UNITED STATES PATENT AND TRADEMARK OFFICE

APPLICATION NO.	FILING DATE	FIRST NAMED INVENTOR	ATTORNEY DOCKET NO.	CONFIRMATION NO.
09/856,661	08/02/2001	Michael Hohmann	MERCK2245	3177
23599	7590	07/19/2004	EXAMINER	
MILLEN, WHITE, ZELANO & BRANIGAN, P.C. 2200 CLARENDON BLVD. SUITE 1400 ARLINGTON, VA 22201			QUAN, ELIZABETH S	
			ART UNIT	PAPER NUMBER
			1743

Office Action Summary

DETAILED ACTION

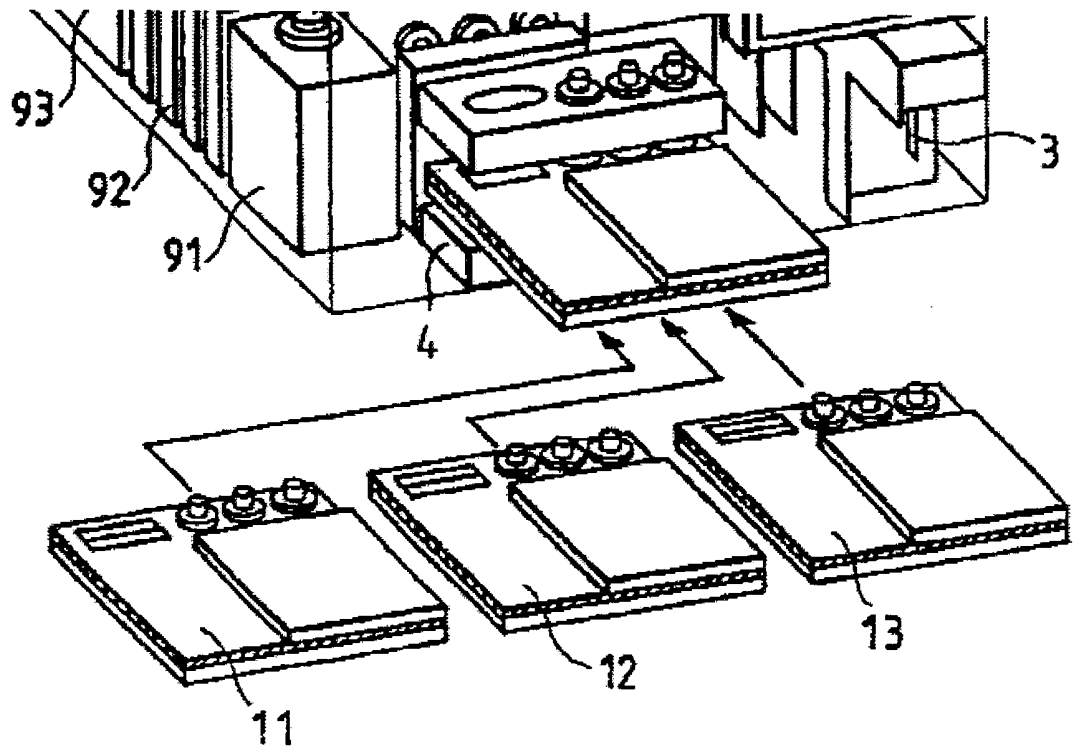
18. Examiner argues that fig. 1 shows a support rail forming an insertion slot by which analytical units are inserted. As shown below, each of the analytical units may be sandwiched by support rails one of which is denoted with reference character "4". An analytical unit is shown sandwiched in between the rails. It appears that the rails are attached to a support plate.

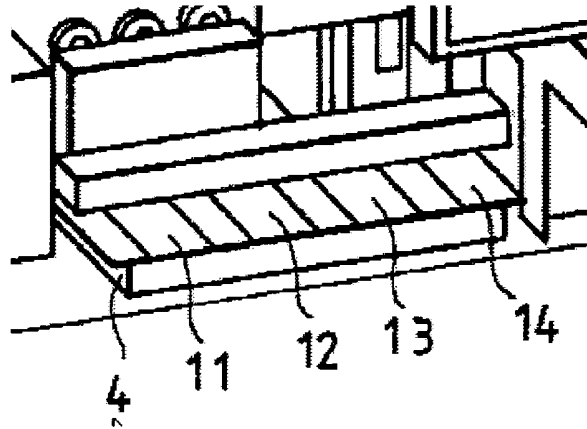
Examiner argues that fig. 11 shows a support rail that forms a slot by which a plurality of analytical units is inserted simultaneously. As shown below, the analytical units appear to be represented as a thin sheet inserted underneath an elongated rectangular block and above a rectangular slab. Even if one were to argue that the analytical units are not inserted between the support rails, it is emphasized that the current claim requires "at least one support rail", such that the support rail in the form of an elongated rectangular block forms an open slot with the rectangular slab below it for placement of the analytical unit above the rectangular slab against the support rail. In this case, the rectangular slab may be considered either another support rail or support plate by which the elongated rectangular block support rail is attached.

Examiner argues that the support rails of either figs. 1 or 11 must be attached to another structure otherwise the support rails would be moved or removed during insertion or removal of the analytical unit, and this support structure can be considered a support plate. Furthermore, the support rail has to be attached to other structure in order to connect the analytical units to elements within the main body (2), such as pump-valve controller (61) and signal processor (62), to provide for chemical analysis. Figs. 3, 12, and 15 show that the support rail(s) is an interface by which the analytical units may connect with other processing elements. The support rail(s) are connected and attached to other structure and processing elements to form a fixed, stationary support to hold analytical units and provide communication between the analytical units and processing elements to perform analysis.
